UNITED STATES PATENT AND TRADEMARK OFFICE

APPLICATION NO.	FILING DATE	FIRST NAMED INVENTOR	ATTORNEY DOCKET NO.	CONFIRMATION NO.
09/887,337	06/25/2001	In Duk Song	8733.425.00	5925

Office Action Summary

DETAILED ACTION

FIG.5

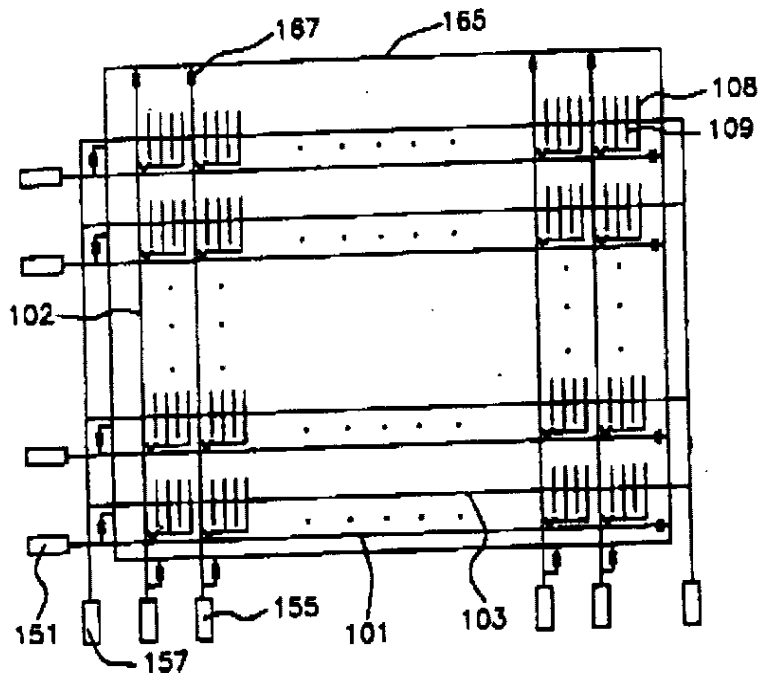
4. Komatsu discloses in col. 5, lines 40-65 and shows in Fig. 5 (reproduced below), an in-plane switching type liquid crystal display device comprising:

- a plurality of data lines (102) for applying data signals to a thin film transistor array;

- a plurality of gate lines (101) for applying gate signals to the thin film transistor array;
- a plurality of gate links extended from the plurality of gate lines (101) into an outer area of the thin film transistor array; and
- a plurality of common voltage lines connected to common voltage pads (157), being provided in such a manner to cross the plurality of gate links, for applying a common voltage to a liquid crystal at the outer area of the thin film transistor array.

Komatsu also shows in Fig. 5 that the common voltage lines are parallel to the gate lines (101).

As to claim 7, Komatsu shows in Fig. 5 that the in-plane switching liquid crystal display device further comprising:

- a plurality of gate pads (151) connected to the gate links and electrically disposed between the gate links and an external power source; and
- a plurality of common voltage pads (157) connected to the common voltage lines and electrically disposed between the common voltage lines and the external power source.

As to claims 8-11 and 14, Fig. 5 of Komatsu also shows that the gate pads (151), data pads (155) and the common voltage pads (157) are located in an area outside of the thin film transistor array.

As to claims 12 and 13, Komatsu also shows in Fig. 5 that at least one common line that is parallel to the data line (102) crosses the gate lines (101) in an area between the gate pads (151) and the thin film transistor array.

As to claims 15 and 16, Komatsu shows in Fig. 5 that at least one common line crosses the data lines (102) in an area between the data pads (155) and the thin film transistor array.

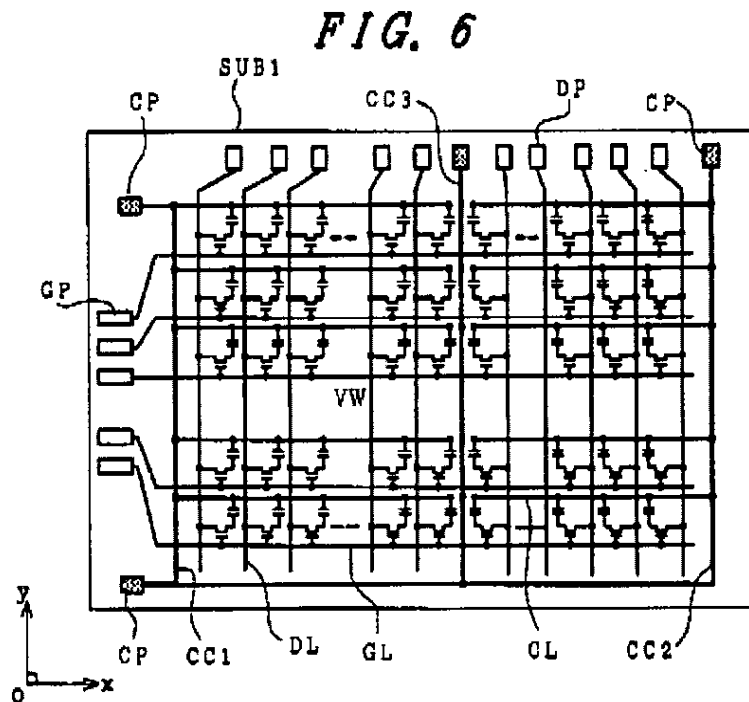
6. Ashizawa discloses in col. 9, lines 27-67 and shows in Fig. 6, an in-plane switching type liquid crystal display device comprising:

- a plurality of data lines (DL) for applying data signals to a thin film transistor array;
- a plurality of gate lines (GL) for applying gate signals to the thin film transistor array;
- a plurality of gate links extended from the plurality of gate lines (GL) into an outer area of the thin film transistor array; and
- a plurality of common voltage lines (CC1, CC2) connected to common voltage pads (CP), being provided in such a manner to cross the plurality of gate

links, for applying a common voltage to a liquid crystal at the outer area of the thin film transistor array.

Ashizawa also shows (Fig. 6) that plurality of gate pads (GP) that are located outside of the thin film transistor array are connected to the gate links and electrically disposed between the gate links and an external power source.

Ashizawa also shows (Fig. 6) that a plurality of data pads (DP) are connected to the data links.

Ashizawa further shows (Fig. 6) that a common voltage line is parallel to the data lines (DL) and a common voltage line is parallel to the gate line (GL).
